# VALUE ENGINEERING REPORT

**SR 20 Improvements from SR 212 to Honey Creek Road**

STP-869(13) PI No. 730907

January 8, 2008

<b>IDEA No.:</b> D-2	<b>Sheet No.:</b> 1 of 4	<b>CREATIVE IDEA:</b> To reduce the median width by 4 feet and use a 2-foot raised concrete median with 1-foot offsets in-lieu-of curb and gutter median.
-------------------------	-----------------------------	---

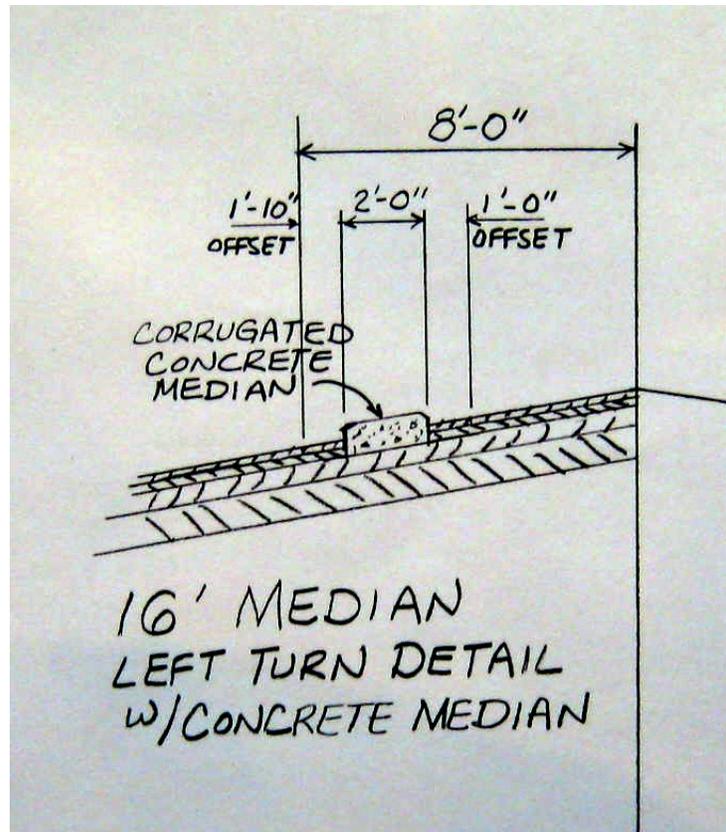
**Proposed Change:** It is recommended that a 16-foot wide median be constructed in-lieu-of the proposed 20-foot raised median. It is further recommended that the resulting 4-foot wide median along the left turn lanes be constructed using a 2-foot wide concrete median with 1-foot offsets from the inside edge of the adjacent lanes.

Reducing the median width 4-feet would reduce the amount of new ROW and earthwork needed to construct the project. Narrowing the ROW would lessen the project's impact on the local community. Constructing the median with a raised 2-foot wide concrete median with 1-foot offsets in-lieu-of dual curb and gutters with concrete median would reduce the amount of curb and gutter, the amount of median pavement, improve project constructibility, and reduce construction time and cost. The raised concrete median would present a clear visual and physical barrier. This concept may require additional adjustments to the outside lanes at intersections to allow for U-Turns.

<b>IDEA No.:</b> A-5	<b>Sheet No.:</b> 1 of 4	<b>CREATIVE IDEA:</b> To realign Brown Bridge Road to line up with SR 212 relocation instead of SR 20 relocation
-------------------------	-----------------------------	--

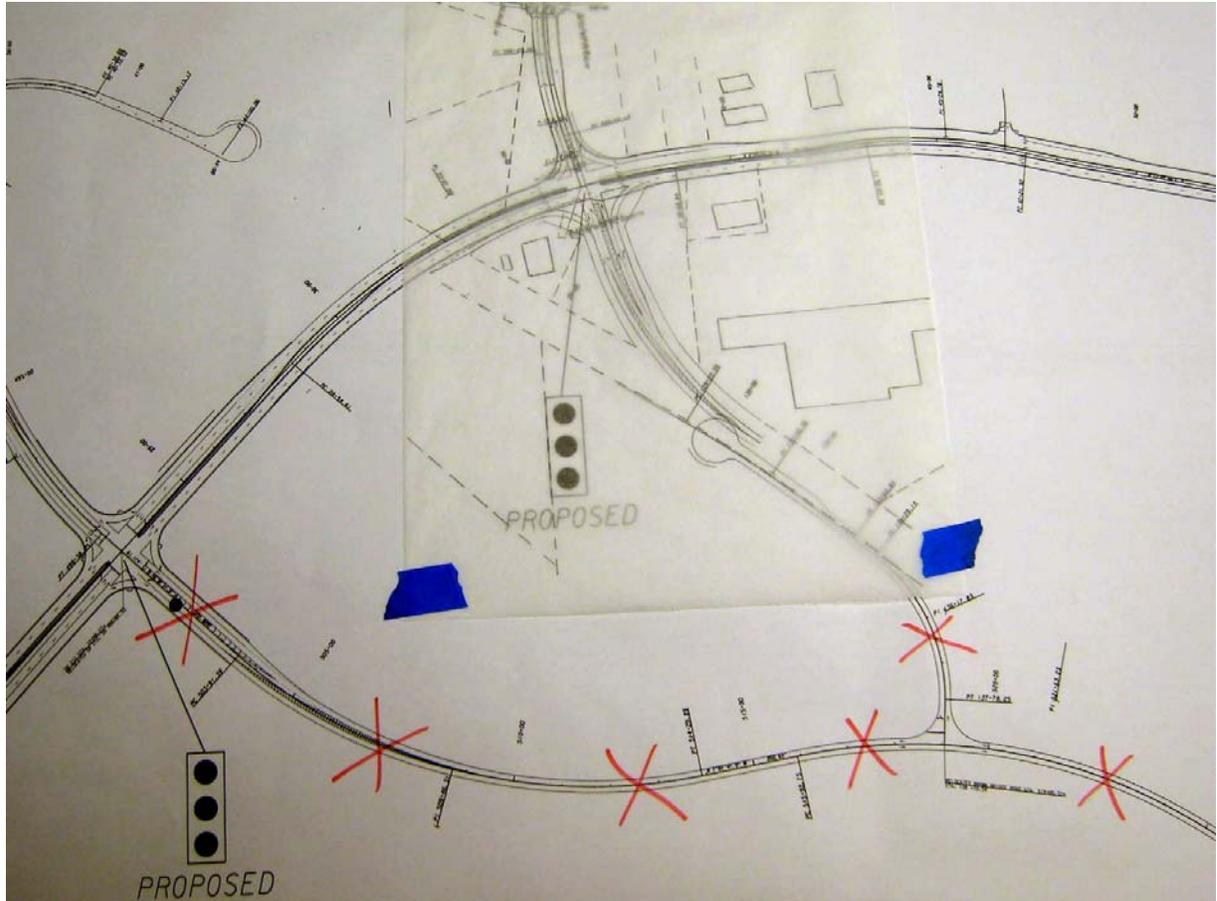
It is recommended that Brown Bridge Road be aligned into the proposed shifted T-intersection between SR 212 and SR 20 just south of the Kroger parking lot. This change would provide route eastbound continuity between SR 212 and Brown Bridge Road.

This change will significantly reduce the length of the Brown Bridge Road relocation and its associated new required ROW. Connecting Brown Bridge Road to SR 20 at the proposed shifted SR 212 intersection would provide for direct eastbound connectivity between SR 212 and Brown Bridge Road. This direct connection would reduce / eliminate traffic that would obviously cut through the Kroger parking lot using the current Brown Bridge Road cul-de-sac design that provides access to the parking lot from the east side.

This realignment concept would also work if the south end of SR 20 is converted to a 5-lane section as discussed in recommendation B-6A.
